PUBLIC INTEREST REVIEW FOR GROUND WATER APPLICATIONS

SUBJECT: Application G- 17504 Supersedes review of _____
Date of Review(s)

A. GENERAL INFORMATION: Applicant's Name: Jeff Boden County: Washington

A1. Applicant(s) seek(s) 0.357 cfs from 1 well(s) in the Willamette Basin,
Tualatin subbasin Quad Map: Hillsboro

Water Levels in Nearby Wells

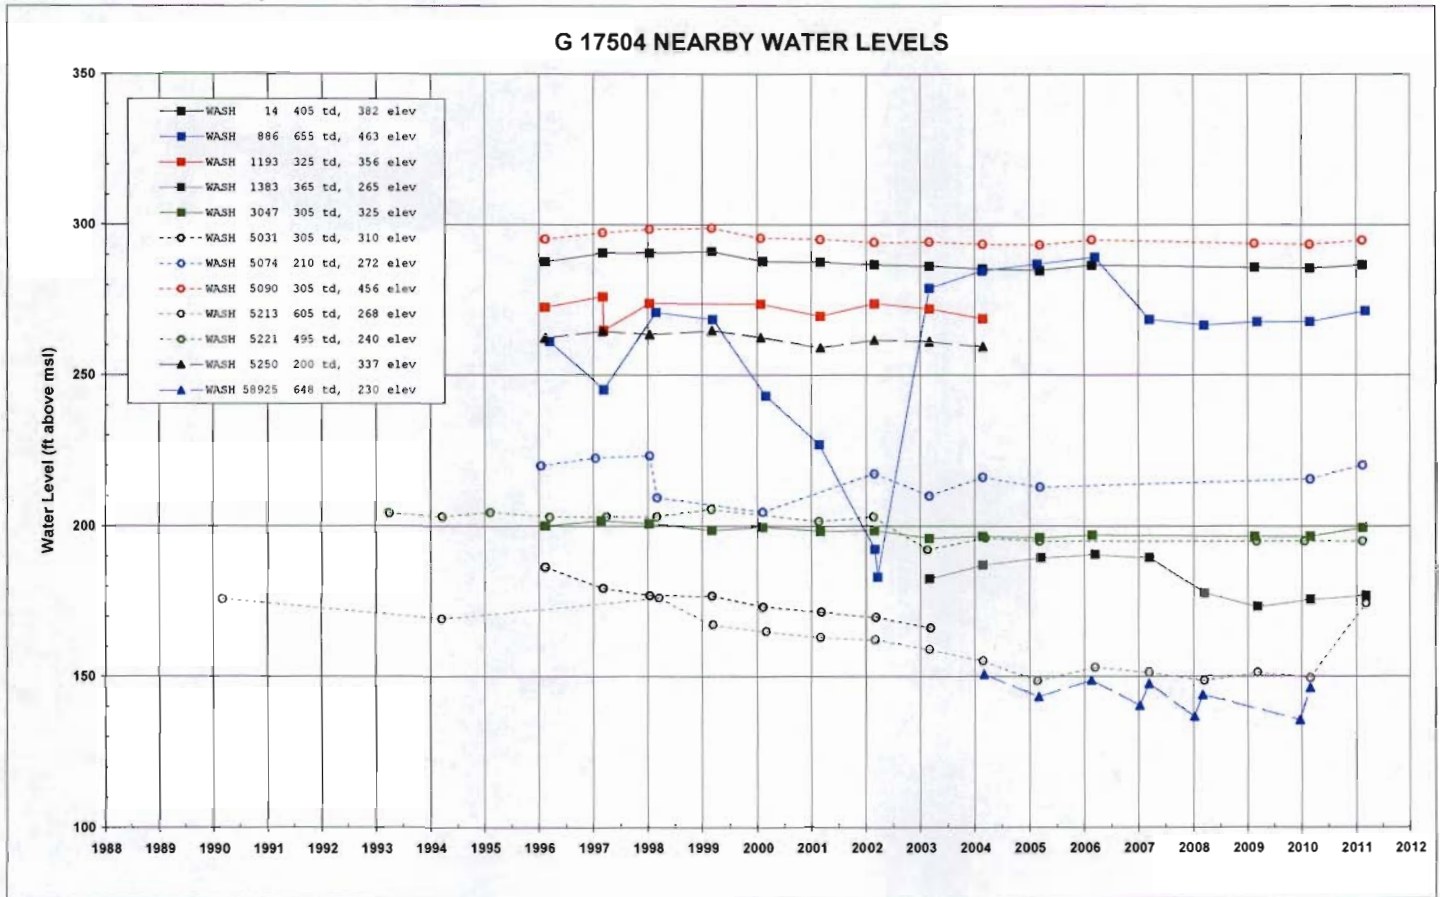
A survey of water levels in nearby wells indicates that shallow basalt wells have shallow water levels and deep basalt wells have deep water levels (see attached hydrograph). The attached hydrograph also illustrates water level trend differences between shallow and deep basalt wells. Water levels in deeper wells (WASH 5213 and WASH 58925) are declining at rates between 1 and 2 feet per year. These declines are caused by over-pumping of the aquifer. Conversely, water levels in shallow wells (WASH 14, WASH 1193, WASH 5090, and WASH 5250) fluctuate in relation to decadal-scale precipitation patterns and have remained relatively stable over time. Water levels in the applicant's well (WASH 5221) are between shallow and deep wells and have declined slightly since 1993. However, they have remained stable since 2003. Based on the available data, it appears likely that WASH 5221 does not produce from the same aquifer as deeper wells that are experiencing water-level declines.

- B3. Ground water availability remarks: **SPECIAL CONDITION: The source of water for this permit shall be the water-bearing zones in the Columbia River Basalt Group that occur in well WASH 5221 between depths of 301 and 454 feet. The well shall not be deepened or altered such that water is produced from other aquifers in the Columbia River Basalt Group.**
